BILL NO. 2003-83

ORDINANCE NO. 5636

AN ORDINANCE TO ADOPT AS THE CITY'S BUILDING CODE THE 2003 EDITIONS OF THE INTERNATIONAL BUILDING CODE AND INTERNATIONAL RESIDENTIAL CODE, TOGETHER WITH AMENDMENTS THERETO, AND TO PROVIDE FOR OTHER RELATED MATTERS.

**AMENDMENTS TO
2003 INTERNATIONAL BUILDING CODE**

FIGURE R602.10.3.1

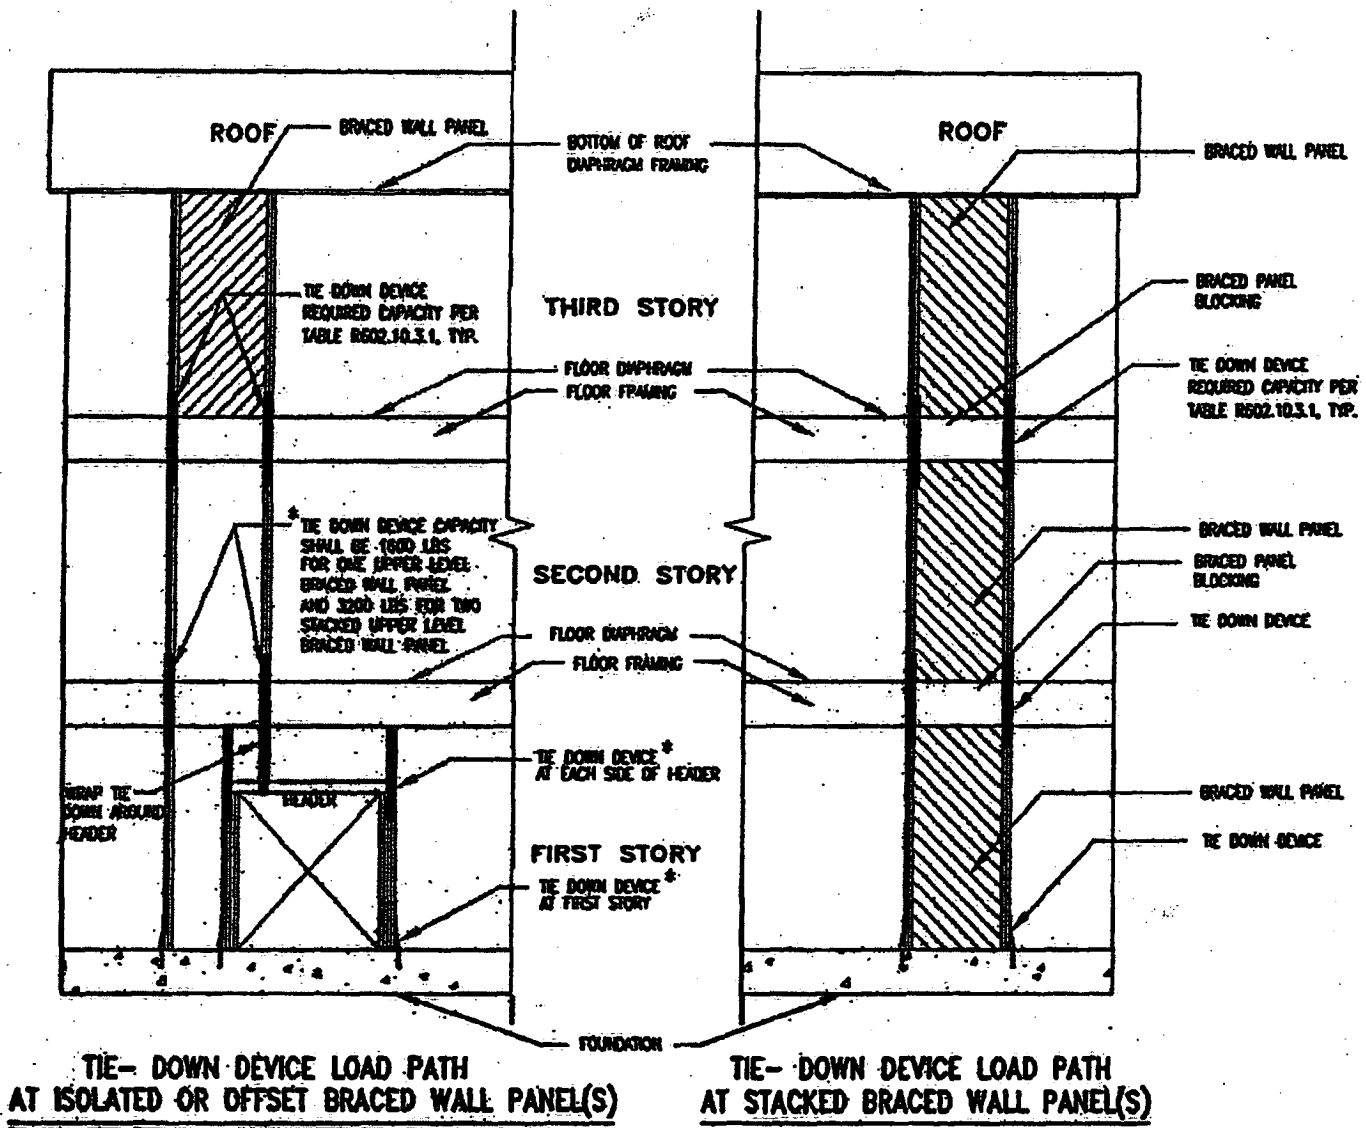
R602.10.3.1 Braced wall anchorage. Braced wall anchorage shall be in accordance with Table R602.10.3 and Figure R602.10.3.1. Braced walls that are not stacked shall be strapped or tied down with devices having a minimum capacity as shown in the table for the story at which the wall occurs.

Figure R606.10(1) ANCHORAGE REQUIREMENTS FOR MASONRY WALLS LOCATED IN SEISMIC DESIGN CATEGORY A, B OR C AND WHERE WIND LOADS ARE LESS THAN 30 PSF

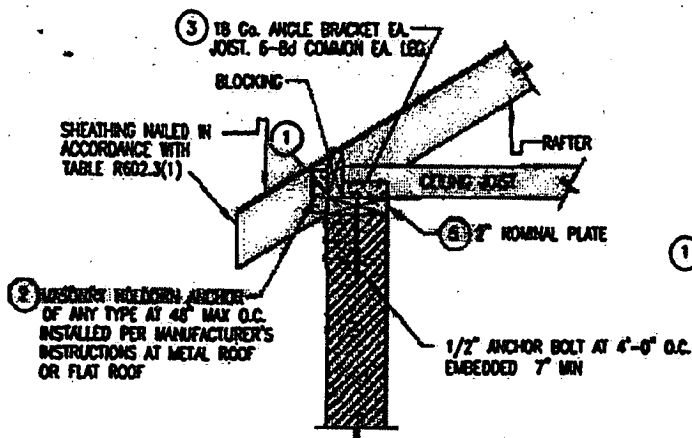
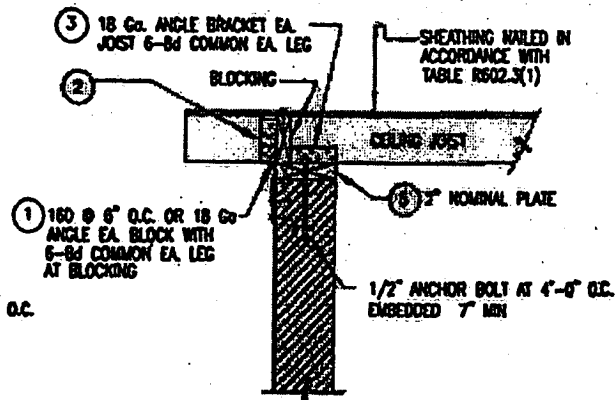
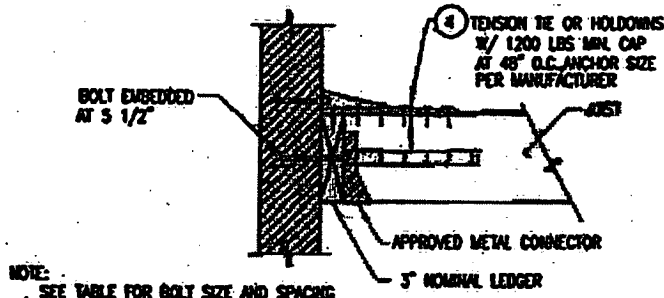
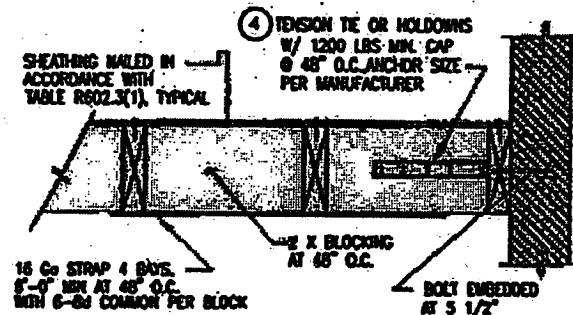
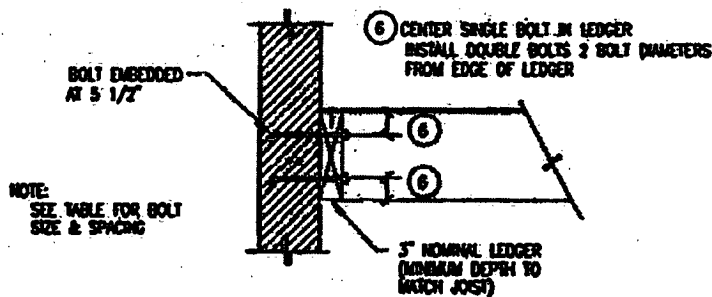
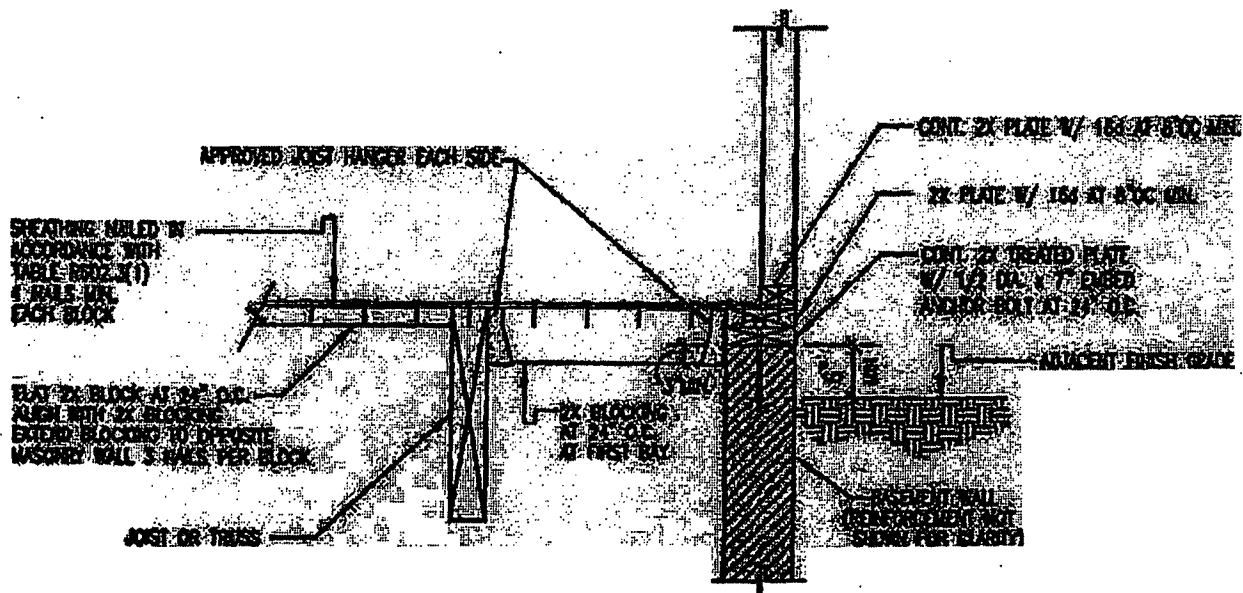
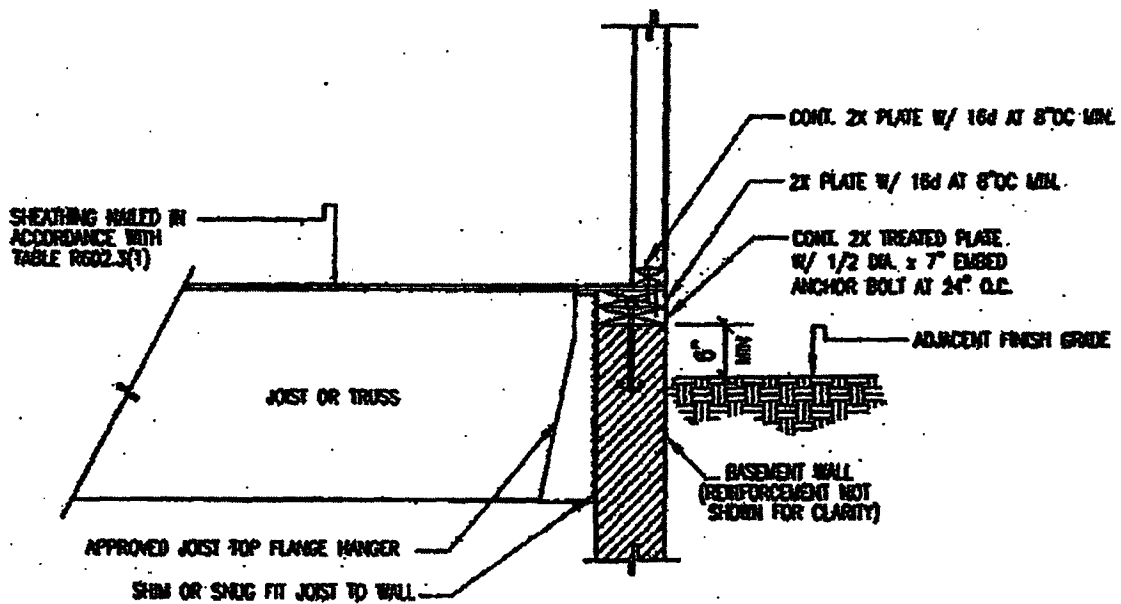
Figure R606.10(1) is deleted and replaced with a new Figure R606.10(1) to read as set forth on Pages 15a and 15b.
